File Number	PL 22-230	Contact	Jenn Moses, jmoses@duluthmn.gov	
Type	Variance – Front yard setback	Planning Commission Date	January 10, 2023	
Deadline for Action	Application Date	December 16, 2022	60 Days	February 14, 2023
	Date Extension Letter Mailed	December 21, 2022	120 Days	April 14, 2023
Location of Subject	110 W Redwing Street			
Applicant	Many Rivers Montessori	Contact	Nicholas O’Connell	
Agent	Arola Architecture	Contact	Ryan Arola	
Legal Description	010-4670-00930			
Site Visit Date	January 3, 2023	Sign Notice Date	December 27, 2022	
Neighbor Letter Date	December 20, 2022	Number of Letters Sent	54

Proposal:
 The applicant is seeking to construct a three-story indoor/outdoor classroom addition with a footprint of 1,542 sq ft. This addition would be partially within the 25’ front yard setback.

PL22-2XX
Variance
110 W Redwing St

MANY RIVERS MONTESSORI CLASSROOM ADDITION
 110 WEST REDWING STREET
 DULUTH, MINNESOTA

Site Photo

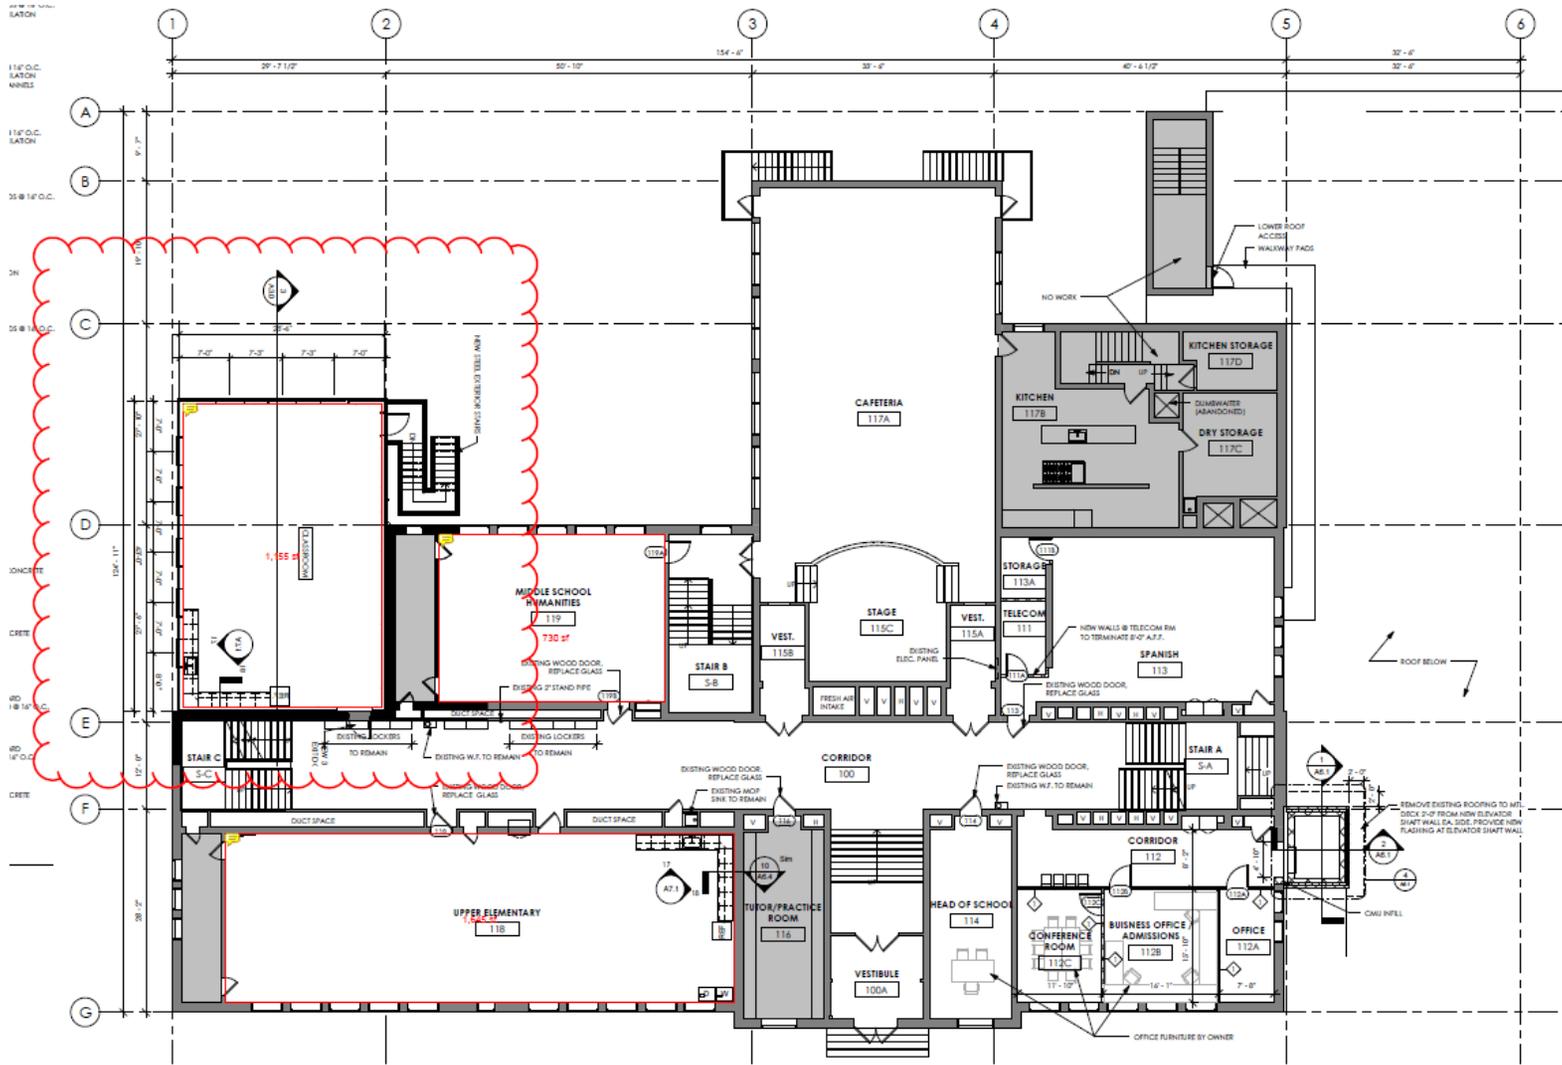
- 1) The existing building has an address on Redwing Street, but--as the zoning code stipulates that the narrowest dimension on a public street shall be the lot front--the front yard setback of 25' applies along Faribault Street. The existing building is approximately 12' from the property line on Faribault Street.

- 4) The applicant is proposing this addition to the southwest of the existing building, as other possible locations would disrupt the school's parking, loading/drop-off, and interior circulation. The addition infills a recessed corner of the building and would encroach no closer to the street than the existing school façade. Because the property line veers south towards the western portion of the lot, the addition would be 14' 9" from the property line on the eastern corner, where it ties into the existing school, and 22' from the property line at the western corner of the addition.

- 6) Because the proposed addition will be no closer to the property line than the existing school building, it is not anticipated to have any impacts on the neighborhood, nor any impacts to light and air for surrounding properties. As the addition includes only one classroom, it is not anticipated to have any significant impact on traffic or congestion in the area.

Based on the above findings, Staff recommends that Planning Commission grant the Variance with the following conditions:

- 1) The project be limited to, constructed, and maintained based on the proposed plan attached to this staff report.
- 2) The plans submitted for the building permit application shall include height calculations for the addition and pergola to demonstrate compliance with the height maximum in the R-1 district.
- 3) Applicant shall provide financial security covering the cost of landscaping approved in 2017 prior to the initiation of any site work; this financial security shall be held, without interest, until the applicant has 1) installed the required landscaping, 2) hired a certified landscape architect to inspect landscaping and confirm that all landscaping was installed correctly and according to approved plans, and 3) forwarded inspection results to the City along with a request for reimbursement of this security. Prior to receiving a Certificate of Occupancy, the applicant shall

Floor Plan Showing Location of Classroom Addition

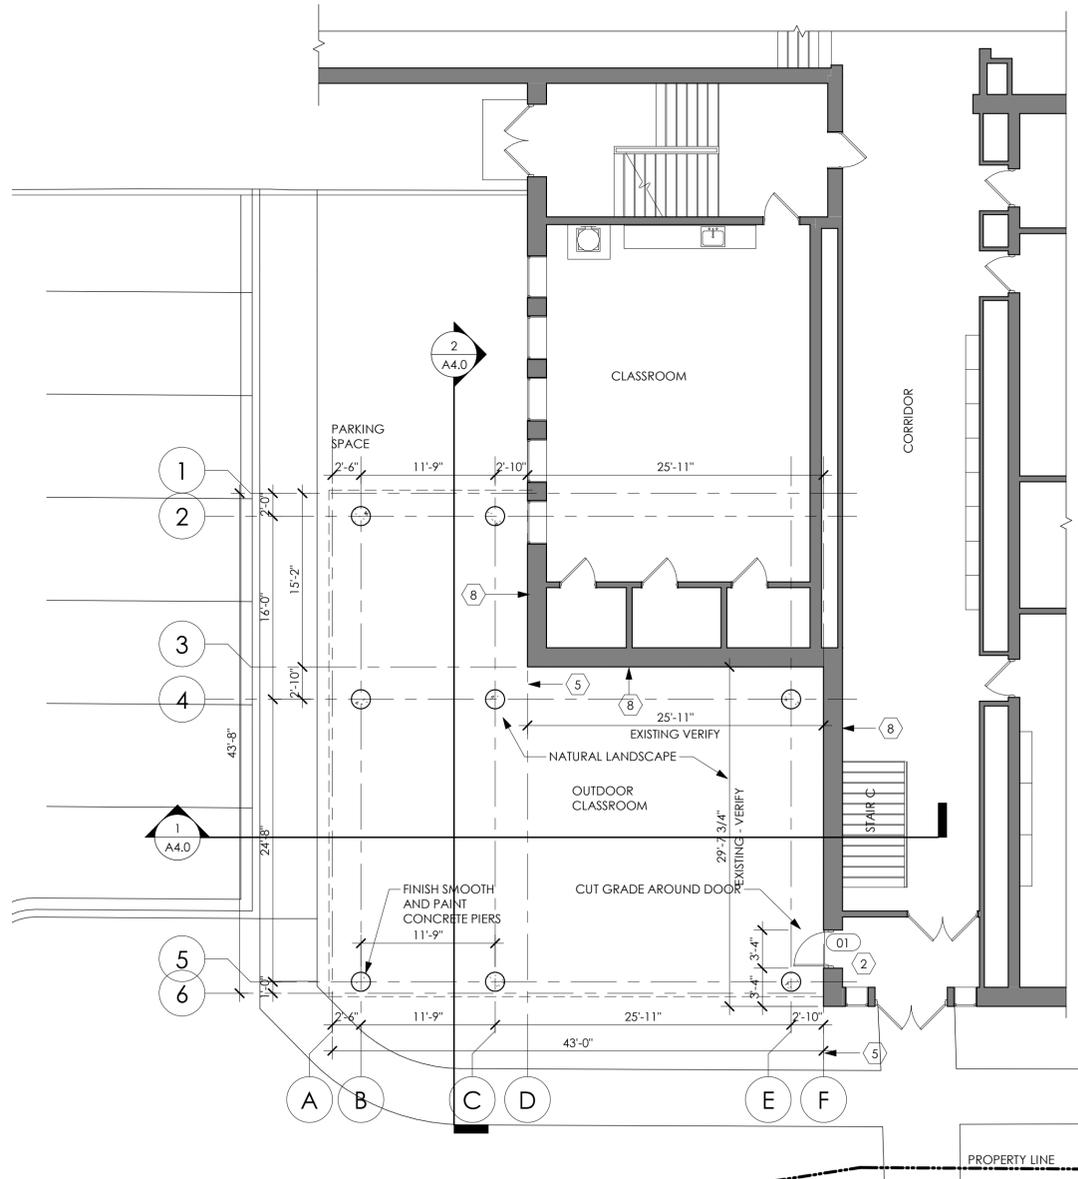
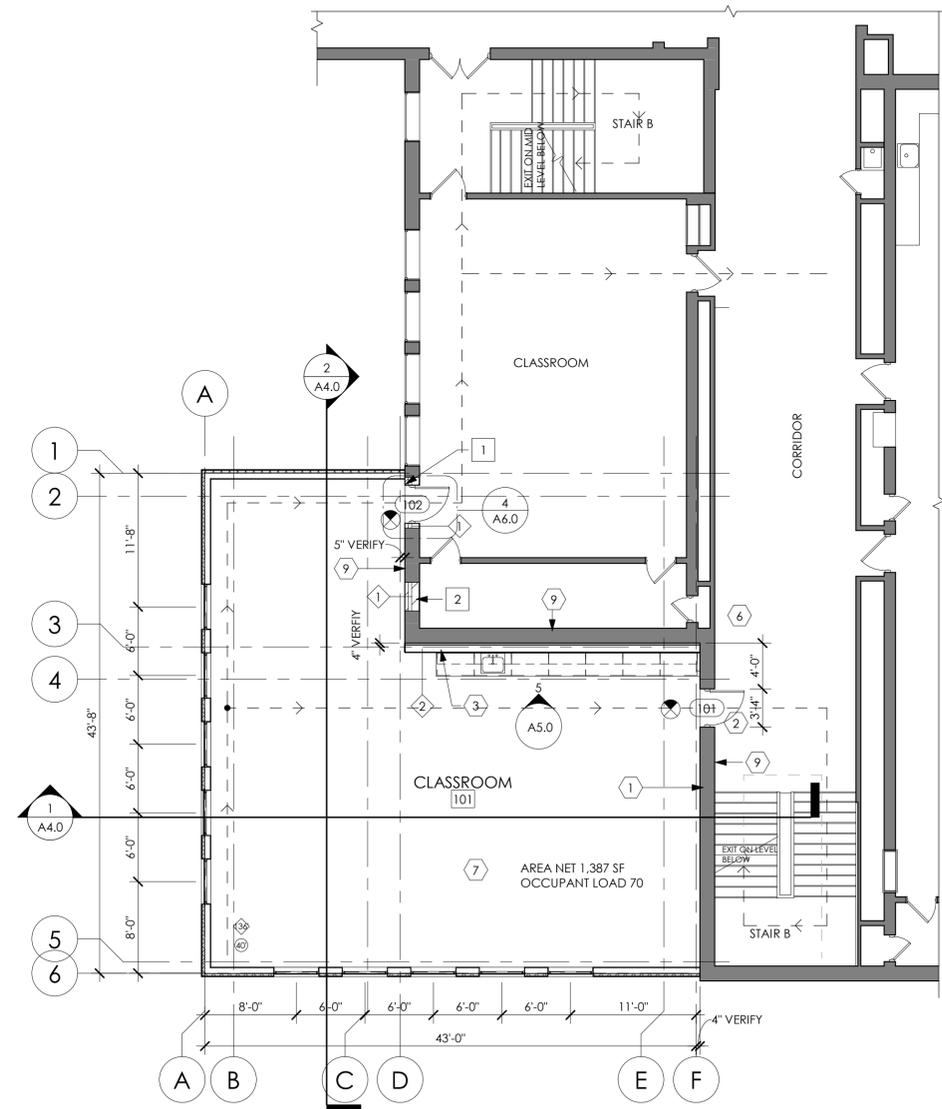
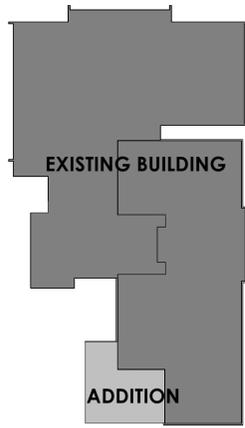
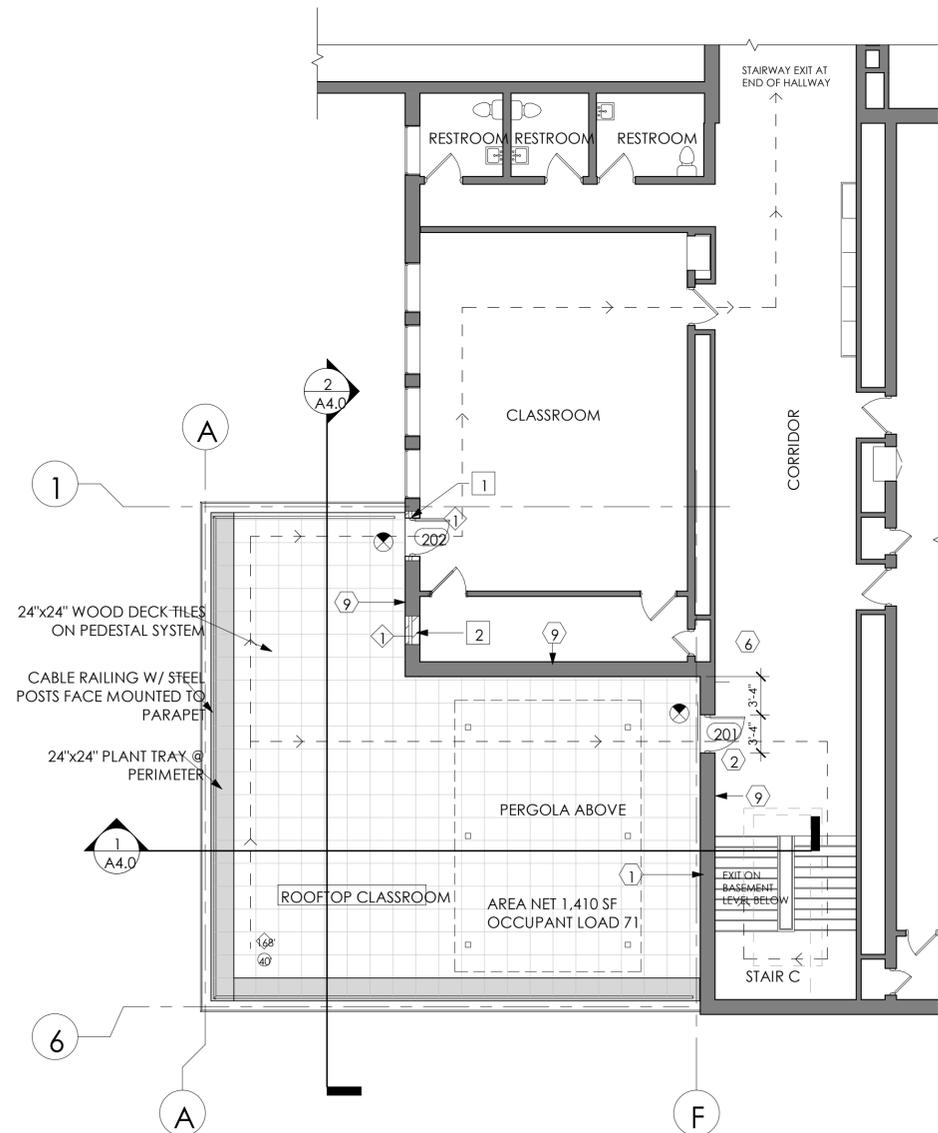
- 3) The applicant proposes an addition to meet enrollment and programmatic needs. This addition would provide a new classroom on Level 1 of the building. The ground level, underneath the classroom, would include outdoor learning space, and the roof of the addition (adjacent to Level 2) would include a rooftop garden and pergola. Staff finds a classroom addition is a reasonable use on the existing site.

A2.1

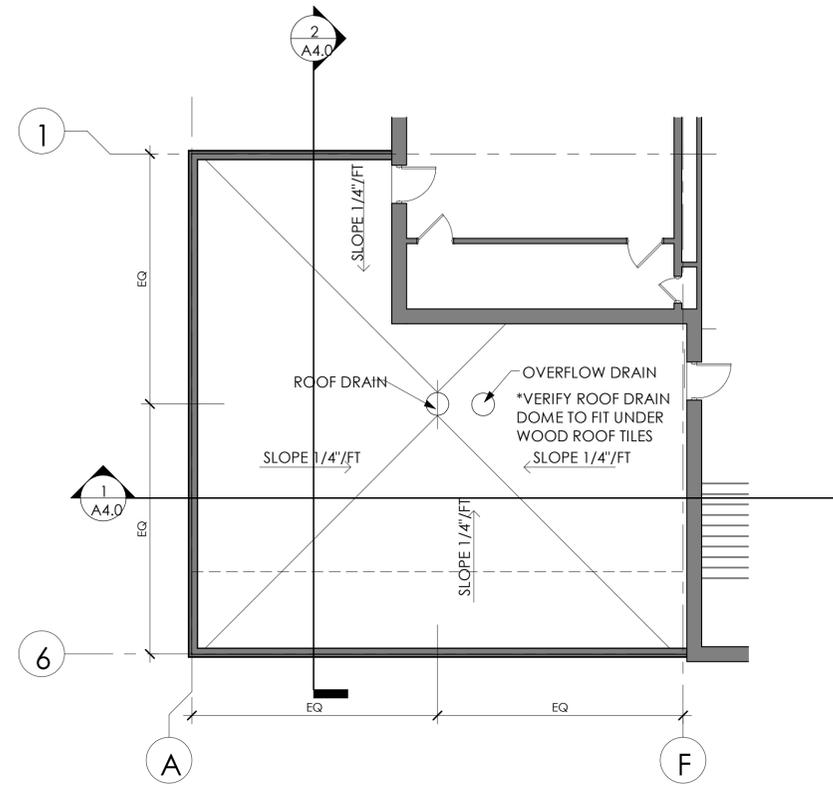
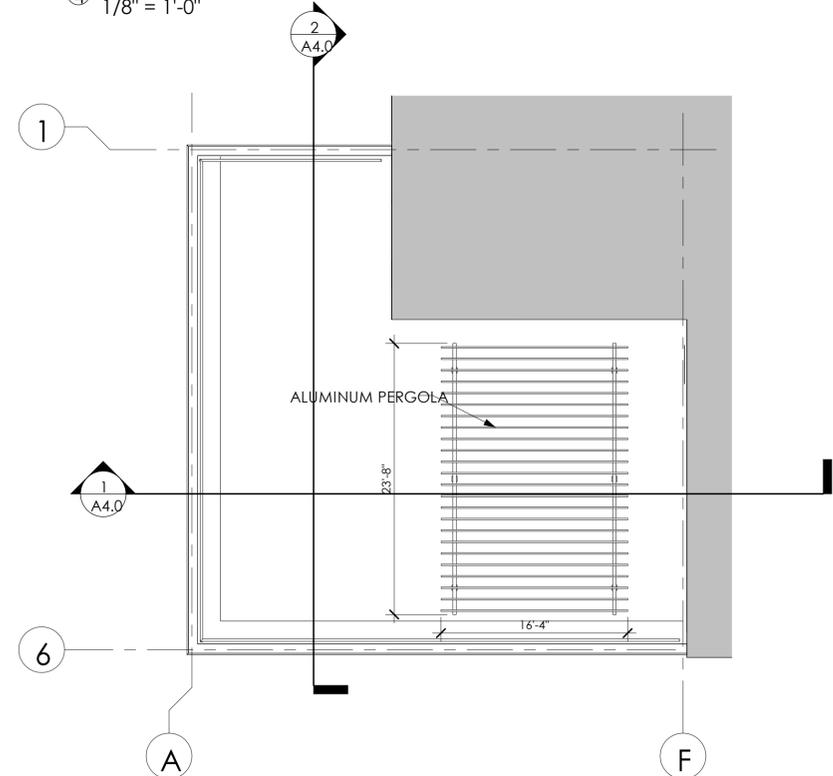
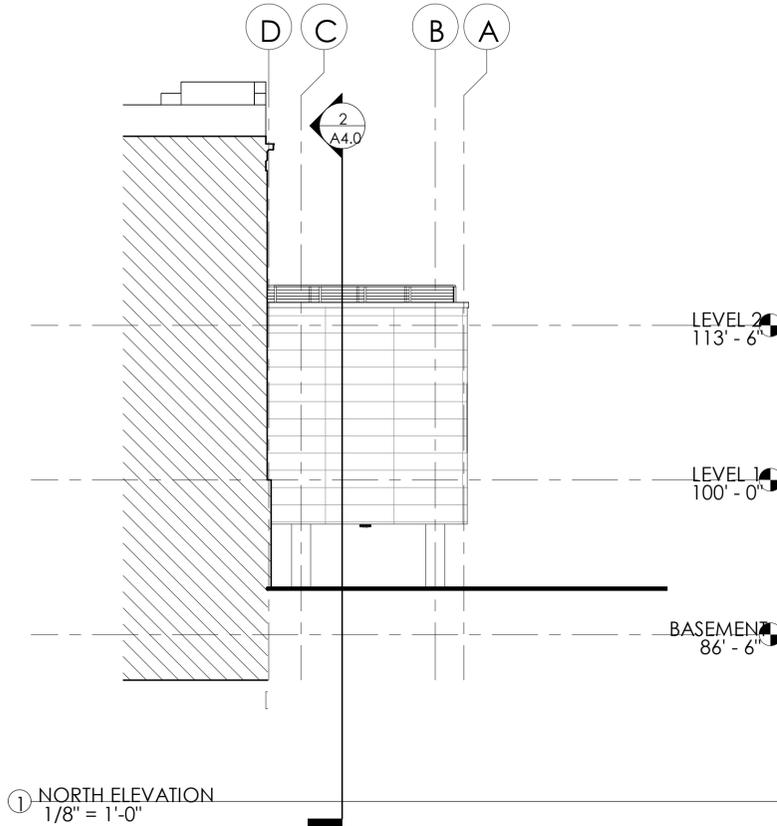
- 7) As this building has existed on the site since 1913, the proposed addition includes only one classroom, and the height of the addition (from grade to the top of the pergola on Level 2) will be 30', this proposal would not alter the essential character of the neighborhood.
